AERAZUR 2 rue Maurice Mallet 92130 Issy les Moulineaux Tél. 33 1 41 23 23 23 Fax 33 1 46 48 83 41	<h2>Service Bulletin</h2> <p>Title : Improvement of the Harness/container Titre: amélioration des sacs/harnais biplaces</p>	BS-25-63-34 Date: 31/07/2007 Page 1/8
--	--	---

Block 1	<u>Technical Background</u>	
a)	Applicability	: <u>Dual harness/containers</u> : 740-1 (ATOM TANDEM) and MMS 740-2 manufactured before 2002 as presented in page 2.

Identification of the containers

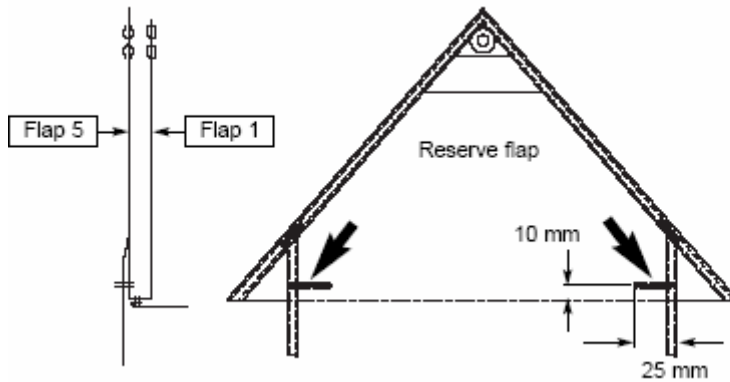
This Service Bulletin concerns these two designs:

First generation

Second generation

This design is not concerned by this Service Bulletin :

Please consider the orientation of the inner flap between the second and the last generation

Improvement:

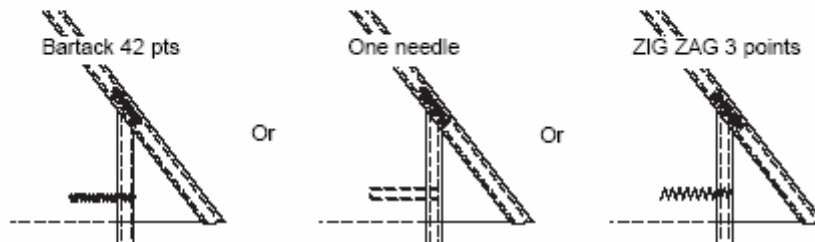
Make a stitching as like drawing upper.

Inside the reserve container

Outside the container

Inside the first generation main container (stitching hidden)

Sewing machine: Bartack 42 pts / One needle / ZIG ZAG 3 points.
Thread: Polyamide 30/3 or size "E" nylon thread
